ENVIRONMENTAL REVIEW COMMITTEE REPORT

Project Name: MeadowVue Preliminary Plat

Project Number: LUA17-000106, ECF, PP, MOD

Project Summary: The applicant is requesting Preliminary Plat approval and Environmental Threshold Determination (SEPA) for a proposed 14-lot subdivision. The project site is 197,762 square feet (4.54 acres) and is located at 13833 156th Ave SE. The project site is located in the Residential-4 (R-4) zoning designation. The proposed single-family residential lots range in size from 9,633 square feet to 11,313 square feet with an overall proposed density of 3.73 dwellings per acre. One existing single-family dwelling will be removed, along with multiple associated accessory structures. Additional proposed improvements include a storm water tract in the southwest corner of the site along the 154th Ave SE frontage. The proposed lots will be served by a new public residential access street that will connect 154th Ave SE with 156th Ave SE. Proposed lots will be served by sanitary sewer along the new street that will connect to an existing main within 152nd Ave SE. Proposed lots will be served by a new water main extending from 156th Ave SE along the new street. Con

EXHIBIT 5

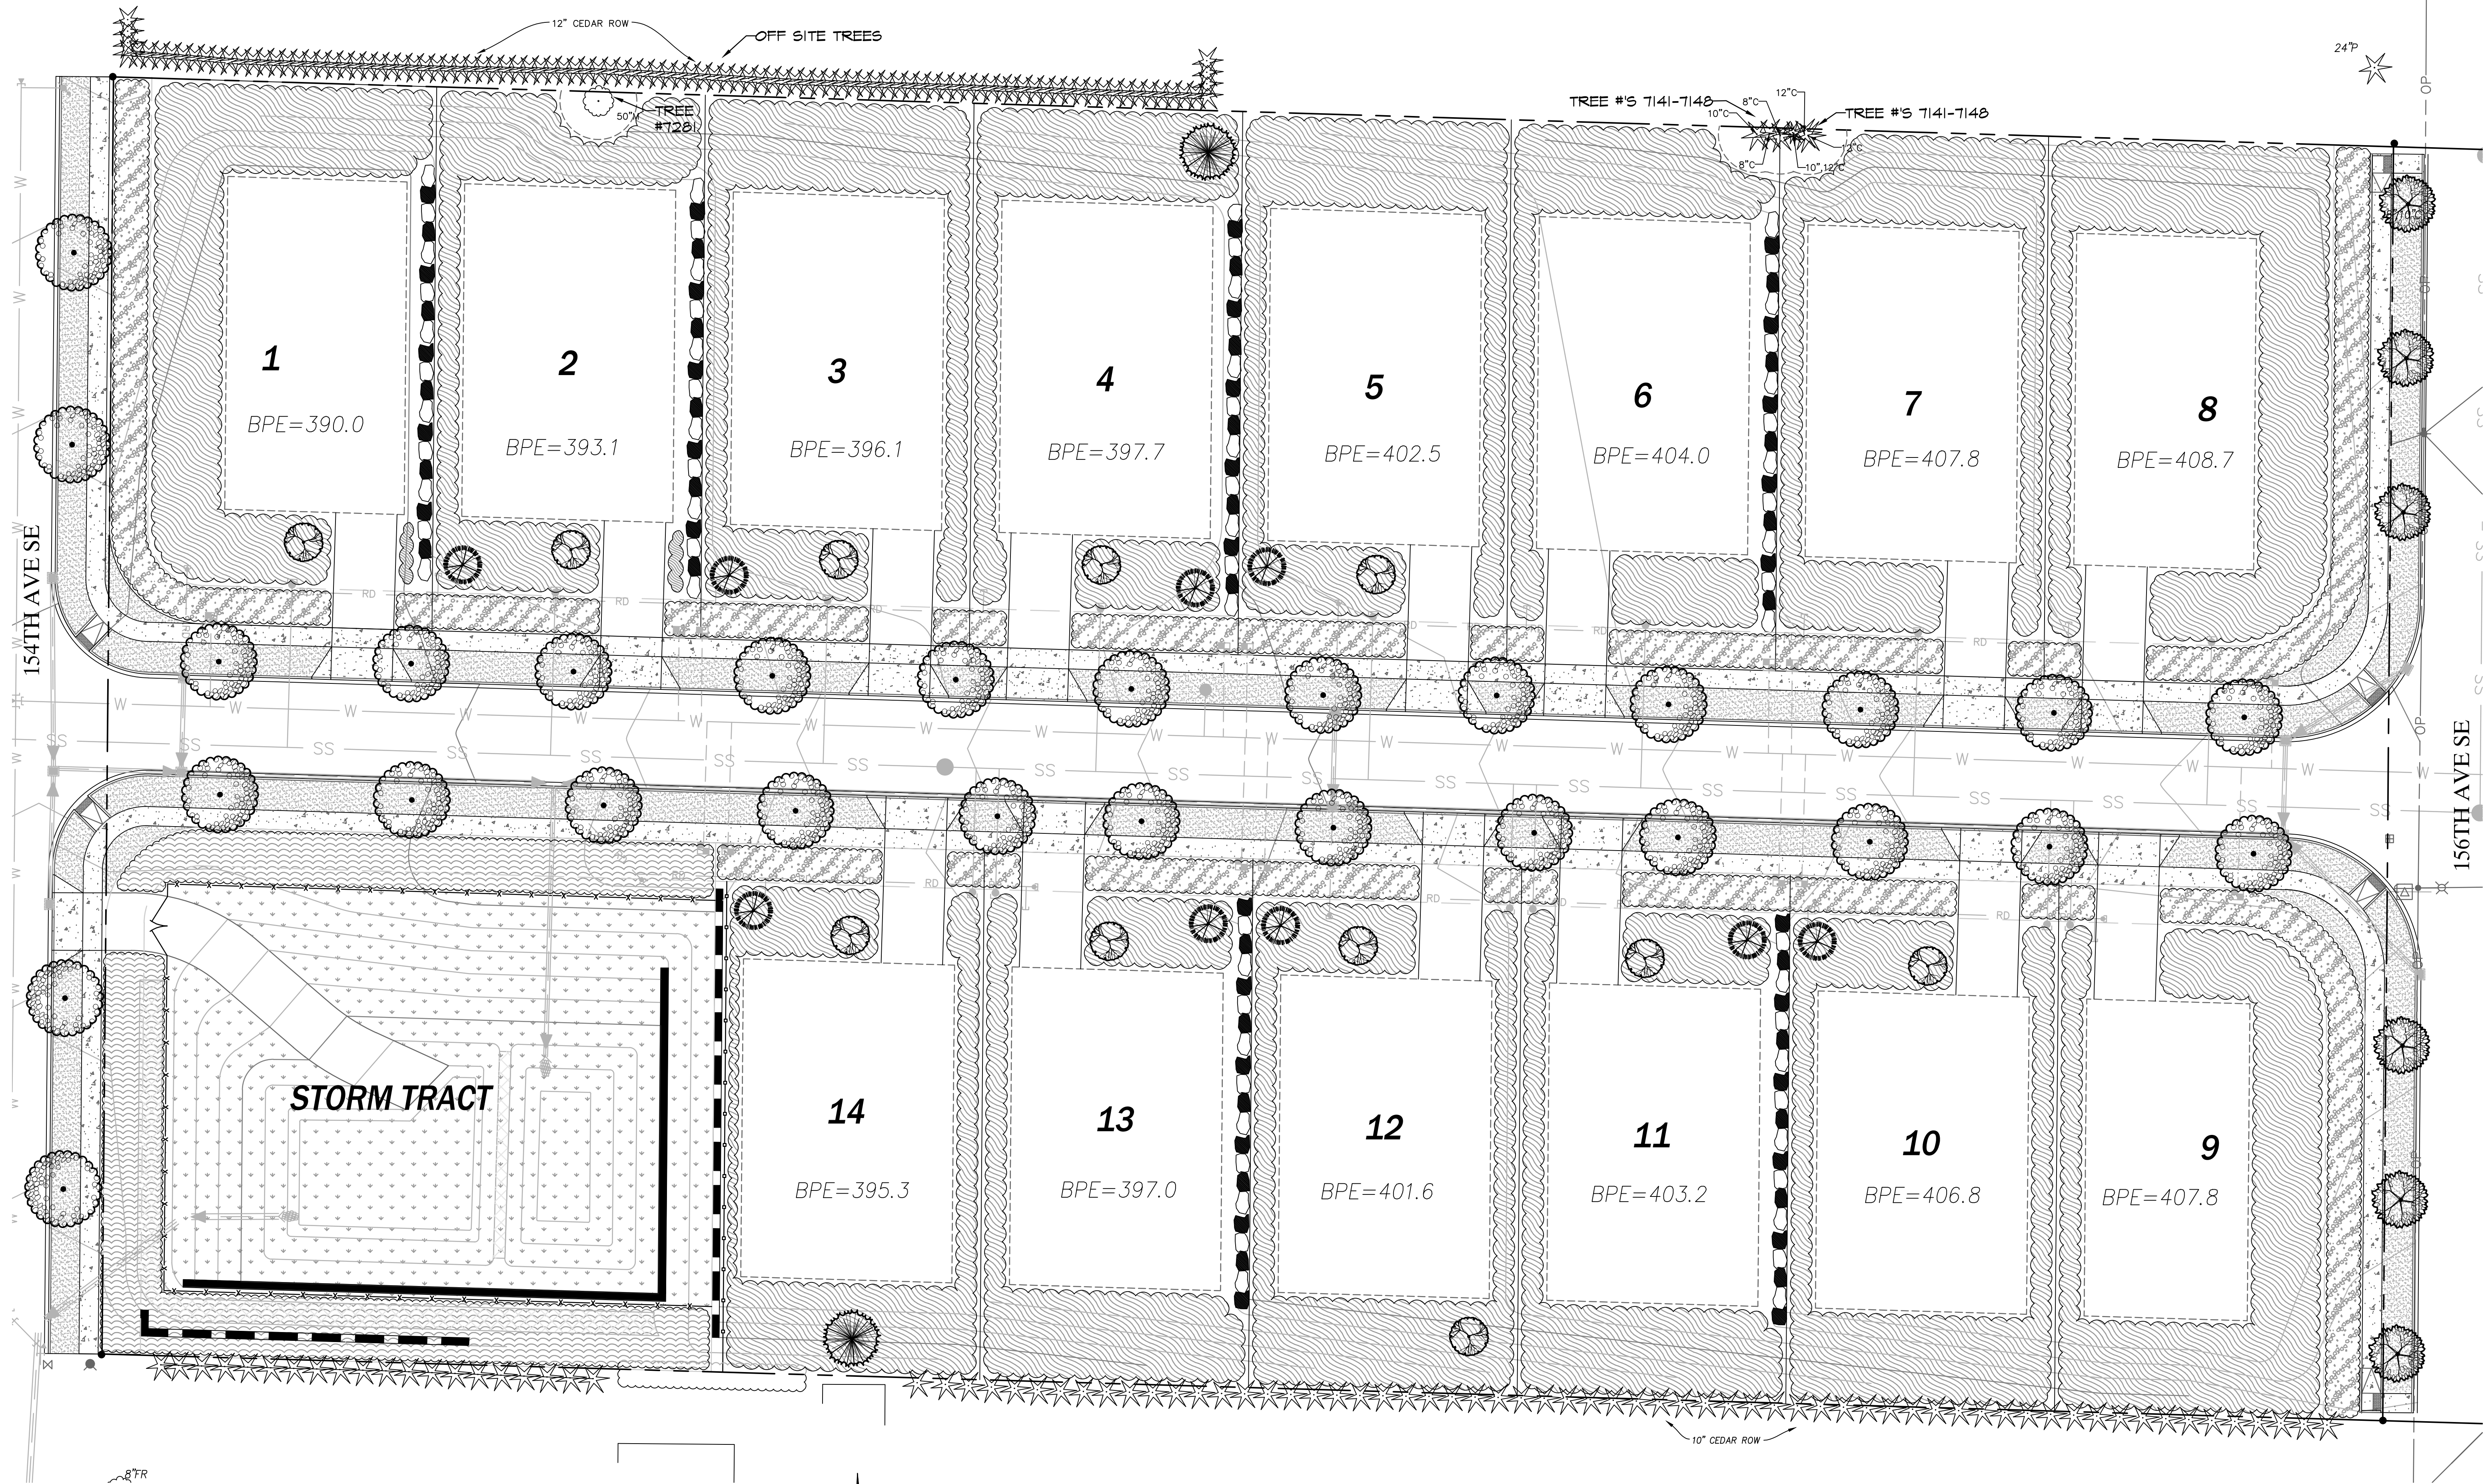
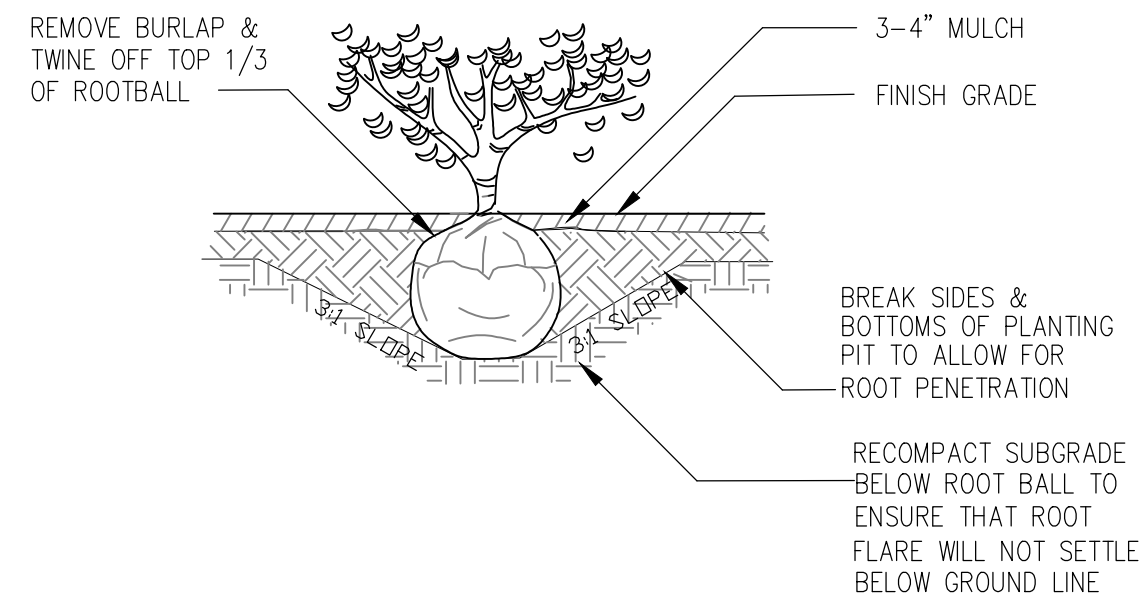
The applicant is proposing to replant the subdivision with 46 new trees including 28 aristocrat flowering pear, 11 Japanese maple, 9 alpine fir, 6 red barron crab apple, and 2 western red cedar. The proposed onsite replacement trees exceed the minimum required replacement inches, 12 inches (12") for every tree that was unable to be retained, or 36 inches (12") for this project. Where there is insufficient ROW space or no public frontage, street trees are required in the front yard(s). Community Services has requested the applicant plant specific tree species (*Exhibit 18*). A final detailed landscape plan must be submitted and approved prior to issuance of the street and utility construction permits.

- Recommendations:
1. Trails should include signed shared Roadway on 156th per adopted trails plan.
 2. Parks Impact fees per ordinance 5824 applies.
 3. Street trees – Do not use Callery Pear, use Skyline Honeylocust, Blue Ash, or Sugar Maple on interior streets and one of these but different along 154th Ave. SE.
